SOUTHERN REGIONAL PLANNING PANEL - ASSESSMENT REPORT

PANEL REFERENCE	PPSSTH-327
DA NUMBER	DA2023.338
LGA	Bega Valley Shire Council
PROPOSAL	<p>3 Lot subdivision with a mixed use development on proposed Lot 1 and associated stormwater works.</p> <p>The proposal comprises:</p> <ul style="list-style-type: none"> • A Torrens Title subdivision of the allotment into three (3) lots (Lots 1, 2 & 3) including road upgrade works along Weecoon Street in front of Lots 1 & 2. • A mixed use building on proposed Lot 1 consisting of: <ul style="list-style-type: none"> ○ A basement carpark containing waste and service areas, resident storage facilities, 55 car parking spaces, 2 wash bays and a single delivery bay. ○ Two (2) commercial tenancies (the subject of future land-use DAs). ○ A shop-top housing development consisting of two residential towers containing a total of 57 units. • Stormwater infrastructure works over proposed Lots 2 & 3, which future DAs for development will incorporate.

ADDRESS	19-21 Weecoon Street, Eden, being Lot 50 in DP 1109545
APPLICANT	Applicant: Benn Lane C/- HDC Planning
OWNER	<p>Multiple owners:</p> <ul style="list-style-type: none"> • Hank Pty Ltd • DC Peters • Luda

FIGURE 15 - PROPOSED STAGE 1 STORMWATER WORKS:

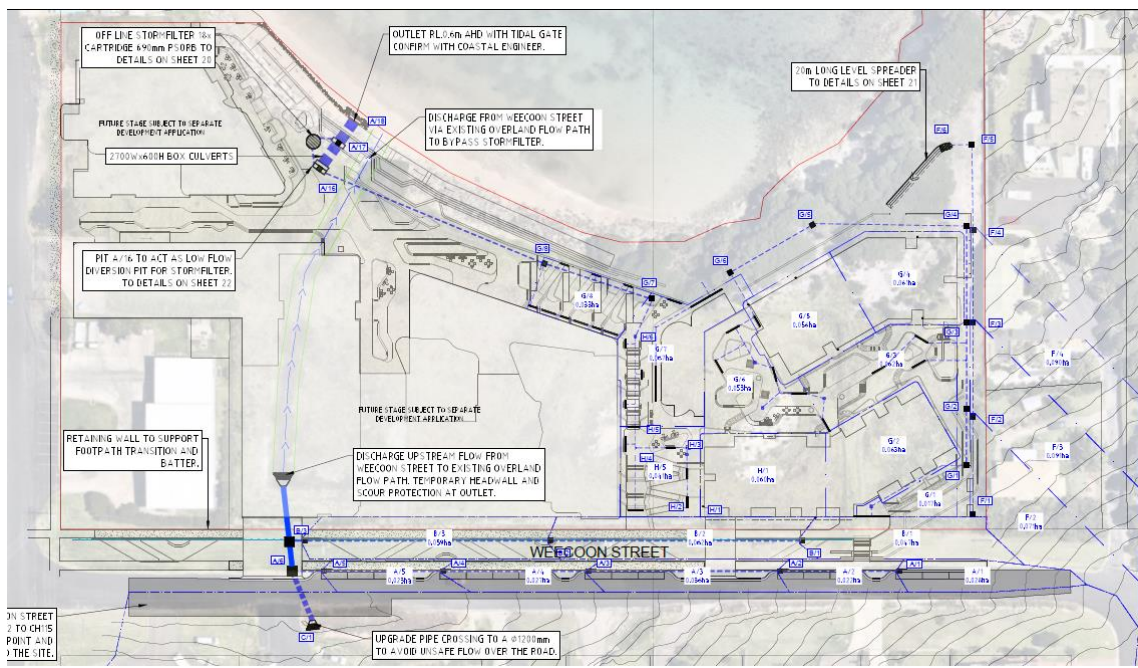
From a review of the submitted documents, the proposed stormwater infrastructure for Stage 1 involves the following elements, as shown in Figure 15 below:

- A new 1200mm diameter piped crossing under Weecoon Street with a new culvert discharging across Stage 2 of the Site via the existing overland flow path with a temporary headwall and outlet scour protection.
- All of the Stage 1 development will be connected to a new 2.7m wide by 600mm high box culvert and off-line Stormfilter at the low point of the Site (on proposed Lot 3). The culverts and Stormfilter are intended to be connected in future stages to an upgraded pipe crossing from the low point on Imlay Street.
- The Stormfilter will have internal dimensions of 3.25m in diameter by 1.8m in height with associated dual control pits.
- Installation of an Oceanguard filter.
- Installation of a 20m long level spreader with an earthen and concrete berm with a 1.5m x 1m rock mattress as scour protection to the north of the proposed Stage 1 building.

FIGURE 19 – PROPOSED RETAINING WALLS:

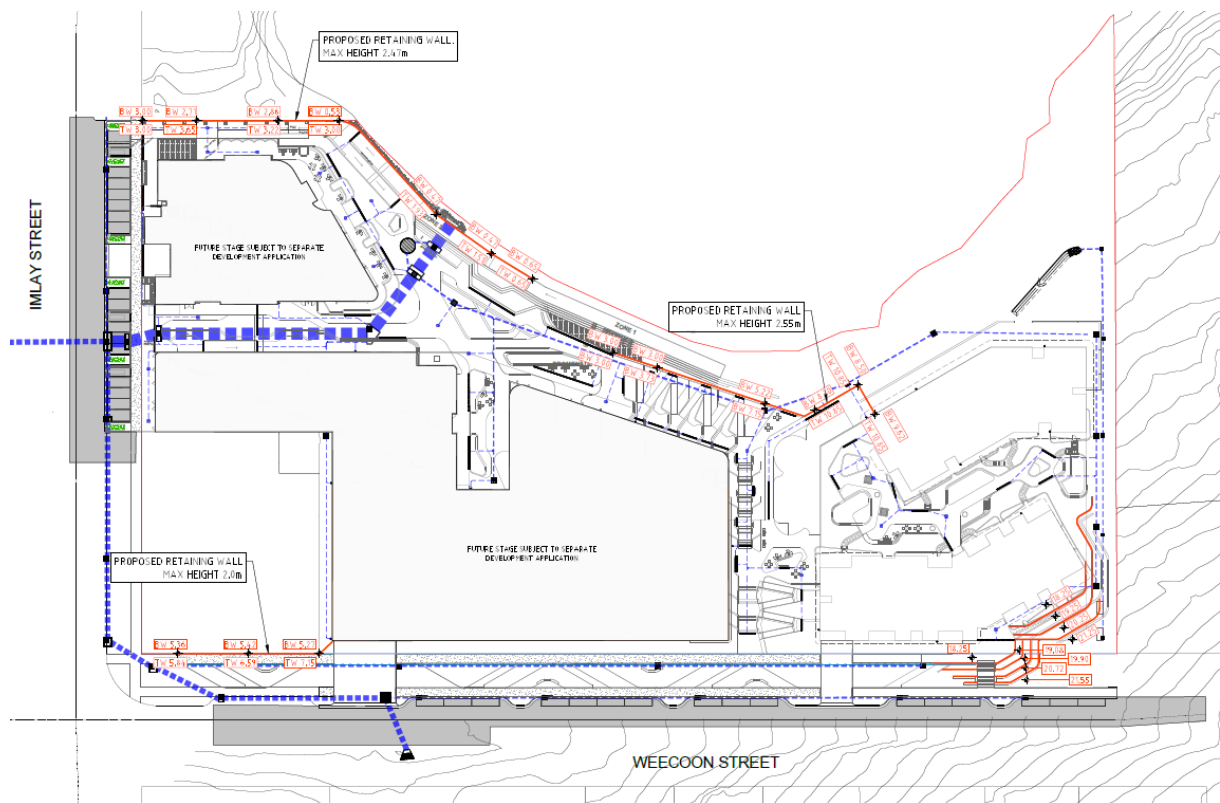
Sheet No. 22 of the Civil Engineering Plan prepared by Siteplus, also outlines a number of retaining walls to be constructed across the entire Site. Although not specifically stated, in order to undertake the works identified in the SEE, retaining walls would need to be constructed as follows:

- These are detailed in Figure 19 below.

FIGURE 20 – DETAIL OF PROPOSED RETAINING WALLS WITHIN ROAD RESERVE:

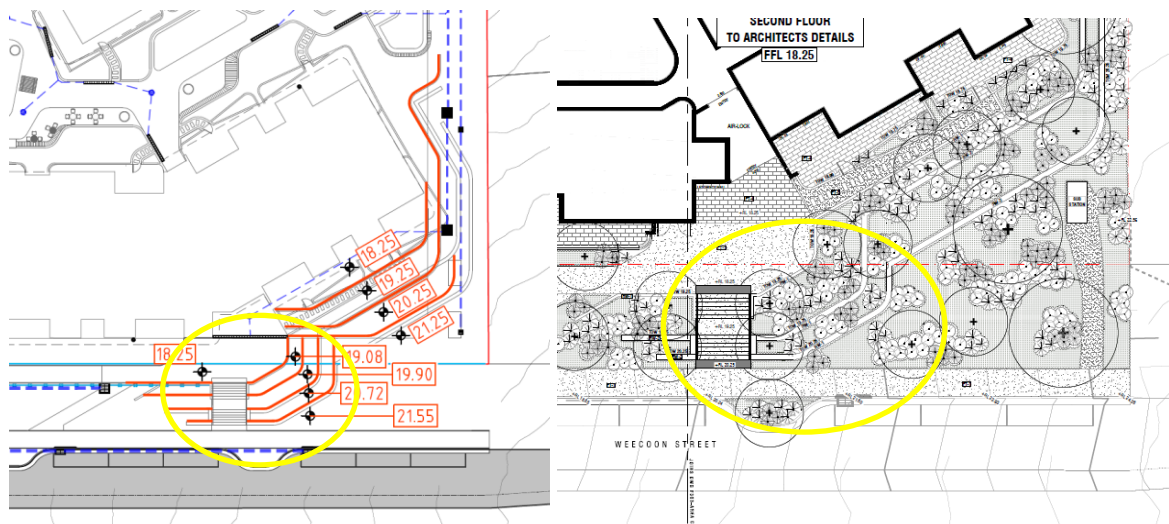
The presence of the retaining walls is also supported by the details contained in the Landscape Plans prepared by dsb Landscape Architects, which include extensive landscaping to the terraces to be constructed within the Weecoon Street road reserve, as shown in Figure 20 below.

FIGURE 21 – PROPOSED SOIL AND WATER MANAGEMENT PLAN:

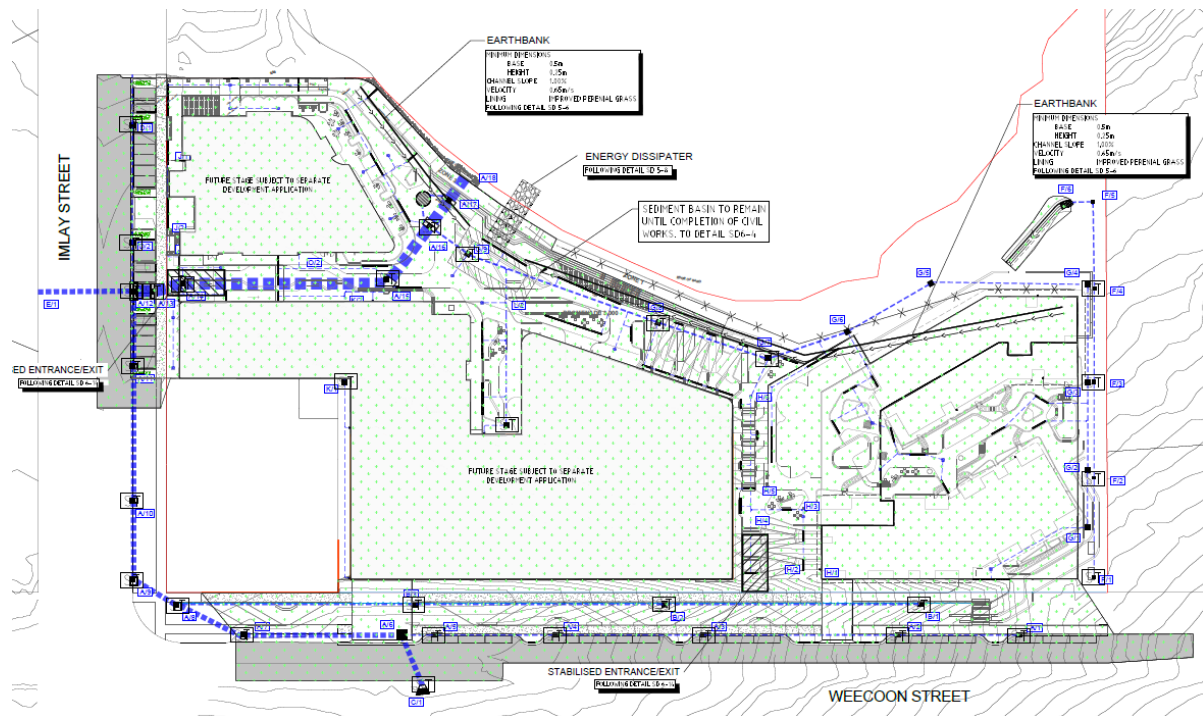
According to Sheet No. 23 of the Civil Engineering Plan, the Stage 1 works appear to also involve the installation of a temporary earthen mound across the Site, feeding into a sediment basin and energy dissipator, with the energy dissipator extending into the waters of

Yallumgo Cove (refer to Figures 21, 22 and 23 below).

<p>which this application relates, although appearing to serve the proposed building.</p> <ul style="list-style-type: none"> • Sheet 23 of 25 (Soil and Water Management Plan) indicates an energy dissipator is to be constructed as part of the temporary stormwater management measures. However, this structure appears to be outside the subject Site and below the MHWL, for which landowners consent from Transport for New South Wales is required. • Details of the measures to prevent the escape of pollutants and sediments from the temporary energy dissipator and sediment basin into Yallungo Cove during design storm events have not been provided. • The Civil Engineering Plans also indicate a level spreader is to be constructed in the northern corner of the Site, within the existing coastal cliff-top vegetation to be retained. Based on the detail provided on sheets 5 and 20 of 25, the level spreader is approximately 20m long by 2m wide with the surrounding ground level filled to a depth of approximately 1.34m surface. Given that it is to be nestled in amongst trees, the installation will result in these few remaining trees being removed. The submitted supporting documents do not provide any assessment of the potential impact on that vegetation, changed hydrological regimes or stability of the nearby cliff face. • The Stormwater Management Study does not appear to take into account the functioning of the rain gardens or level spreader, their role in achieving water quality and quantity objectives or factor in maintenance activities, unlike the Stormfilter and Oceanguard devices. <p>Subdivision/ staging</p> <ul style="list-style-type: none"> • The Plan of Subdivision does not demonstrate how public access to and along the foreshore is to be achieved (e.g. dedication of land, creation of a ROW etc). • The staging is unclear. A staging plan was requested that clearly identifies the entire area encapsulated in Stage 1 of the development and identifies any ancillary works such as stormwater drainage and water quality works, public access, augmentation of utilities, street tree planting, footpath and kerb and guttering and the like.

FIGURE 24 – SAMPLE OF PROPOSED PUBLIC DOMAIN WORKS:

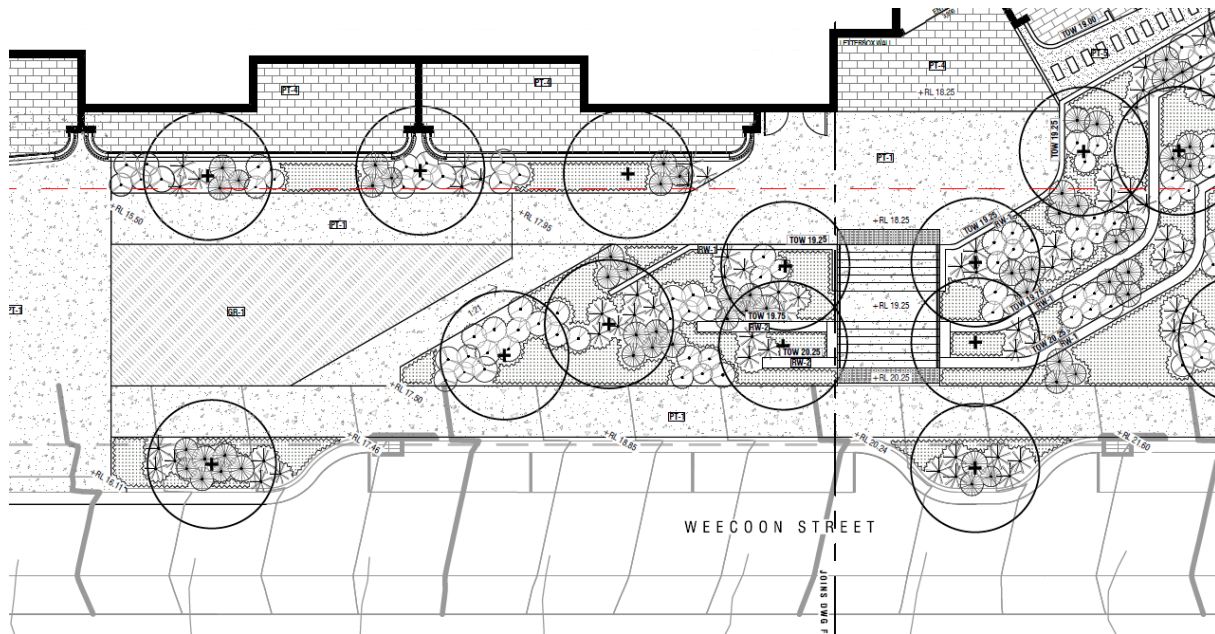
Drawing No. DA004, Rev A dated 27/9/2023 prepared by ELK Designs, is notated with "Stage 1B (Public Domain and Roadworks)" along the Weecoon Street frontage. The drawing however lacks any details. The Landscape Drawings prepared by dsb Landscape Architects indicates the following works would be undertaken as part of the Stage 1 works, as shown in Figure 24 below:

The submitted Civil Engineering Plan also states that Weecoon Street is to be reconstructed from CH.52 to CH.115 to grade out an existing low point and overflow into the Site. From CH.115 to CH.276.35, Weecoon Street is to be reconstructed only for half-width.

FIGURE 25 – PROPOSED TREE REMOVAL:

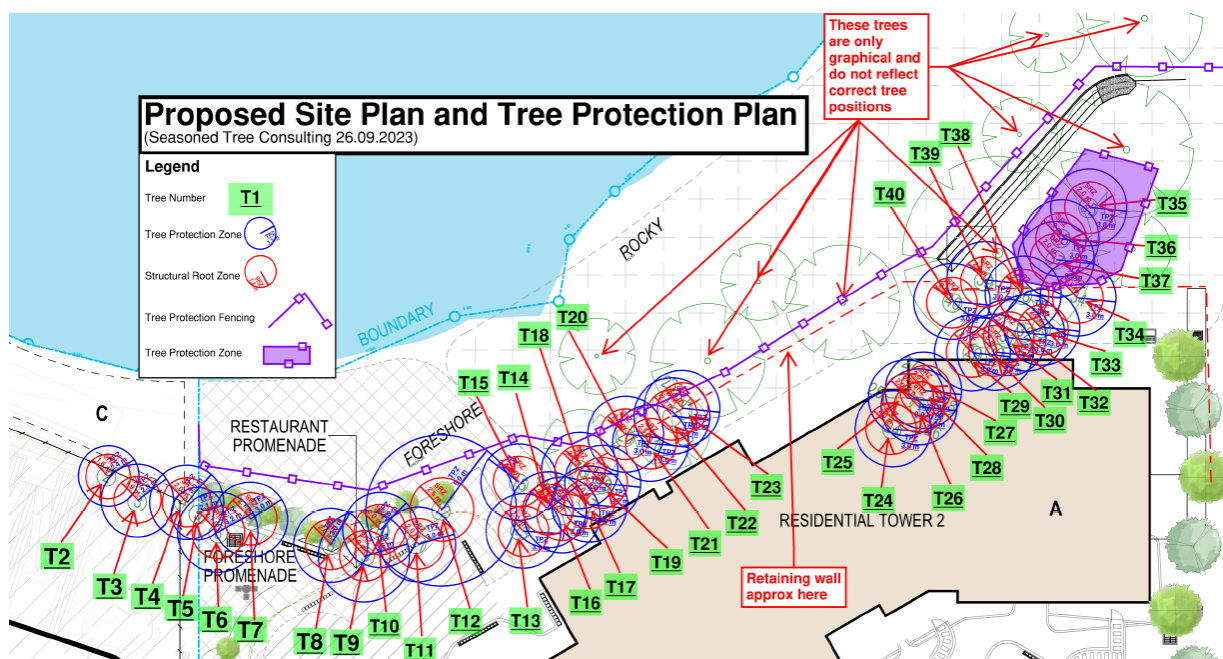
On the other hand, the Arboricultural Impact Assessment Report prepared by Seasoned Tree Consulting indicates that 34 of the 40 trees surveyed are to be removed as a result of the proposed building, as shown in Figure 25 below.

The report also notes that two of the four trees to be retained are in fact a species of

pittosporum that does not require approval from Council to remove, as it is deemed to be an invasive species. An unknown quantum of additional vegetation will be removed as a result of the proposed level spreader, of which there has been no assessment in relation to its placement.

FIGURE 26 – INDICATIVE SIGNAGE DETAILS:

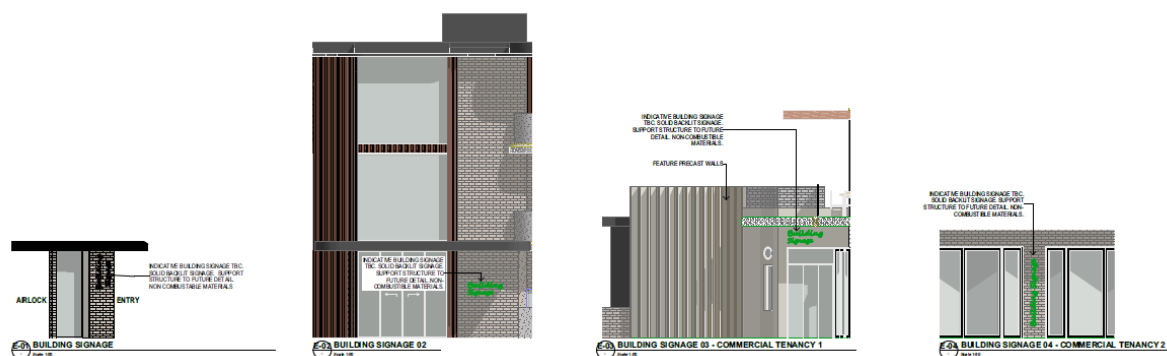
The submitted plans also detail the indicative signage at two separate building entry points (presumably for way-faring purposes), as well as indicative signage for each of the two commercial tenancies. The indicated signage generally consists of solid, back-lit lettering however no further details such as dimensions, have been provided.

FIGURE 32: BUILDING HEIGHT PLANE ANOMALIES

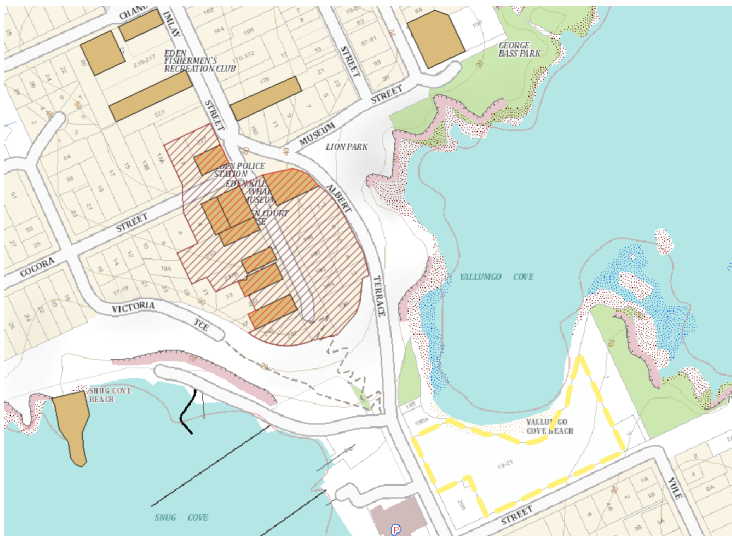
4.3 Height of Buildings	<p>Maximum permitted: 13m</p> <p>Proposed (as stated in the SEE): 17.39m</p> <p>Proposed (as per stated RLs): 19.305m</p>  <p>The majority of the northern tower exceeds the 13m height limit while the NW portion of the southern tower is in breach. The 3D drawings demonstrating the application of the height plane across the Site does not appear to correlate to the height plan shown dotted in red on the elevations.</p> <p>Additionally, the height plane shown dotted in red on the elevations does not appear to correlate with the adjoining elevations – for example the northern and western elevations as shown in Figure 32 below.</p> <p>The scale of the development vs the small size of the height plane diagrams (which lack adequate levels) makes it difficult to accurately determine the true extent of the breach.</p>	<p>YES <input type="checkbox"/></p> <p>NO <input checked="" type="checkbox"/></p> <p>N/A <input type="checkbox"/></p>

<p>What is the difference between the development standard and the proposal?</p>	<p>Maximum permitted height: 13m</p> <p>Proposed (as per the SEE): 4.39m or 33.8% (17.39m)</p> <p>Proposed (as per plans): 6.31m or 48.5% (19.31m)</p> <p>The majority of the northern tower exceeds the 13m height limit while the NW portion of the southern tower is in breach.</p>
<p>Has the submission provided a visual representation of the variation?</p> <p>Are the details legible?</p>	<p>YES <input checked="" type="checkbox"/> NO <input type="checkbox"/></p> <p>YES <input type="checkbox"/> NO <input checked="" type="checkbox"/></p> <p>The scale of the building height planes and elevations as presented on the plans obscures much of the detail and the lack of sufficient levels or dimensions means that verifying the accuracy of the applicant's claim is difficult. The statements made in the SEE regarding the exceedance of the maximum building height cannot be supported when the levels provided are examined.</p> <p>Further, the 3D drawings demonstrating the application of the height plane across the Site do not appear to correlate to the height plan shown dotted in red on the elevations and in Figure 32 above.</p> <p>Additionally, the height plane shown dotted in red on the elevations does not appear to correlate with the adjoining</p>

Relevant Consideration:	Response:
	<p>elevations – for example the northern and western elevations. The lack of adequate supporting drawings means that the Panel cannot be satisfied that the applicant has fulfilled its obligations with respect to Cl. 4.6(3)</p>
<p>What are the objectives of the development standard being varied?</p>	<p>(a) to ensure new development is appropriate in the context of the predominant form and scale of surrounding development, including present and likely future development, surrounding landforms and the visual setting,</p> <p>(b) to protect residential amenity, views, privacy and solar access.</p> <p>The applicant's submission misquotes Objective (a) of Cl. 4.3(1), stating instead that it is:</p> <p><i>“(a) to retain the existing character and landscape of the locality and to encourage a low-set building form”.</i></p>
<p>Does the proposed variation satisfy the Objectives?</p>	<p>YES <input type="checkbox"/> NO <input checked="" type="checkbox"/></p> <p>The proposal is inconsistent with the existing built form and desired future character, as expressed in the area-specific Snug Cove Masterplan with respect to building height, bulk, mass and scale. The proposal has not been formulated using accurate or consistent documentation and lacks significant information to demonstrate how it will operate in the context of the surrounding development.</p> <p>The proposal also requires significant modification of the Site in order to be built and will result in the loss of vegetation identified for protection. The proposal also fails to demonstrate that it will provide adequate levels of internal amenity or that it will not adversely affect the views and privacy of adjoining properties.</p> <p>The information provided also fails to accurately and adequately demonstrate the impact on the landform of the coastline or views of and to the foreshore from the public domain. Overall, the information provided only serves to</p>
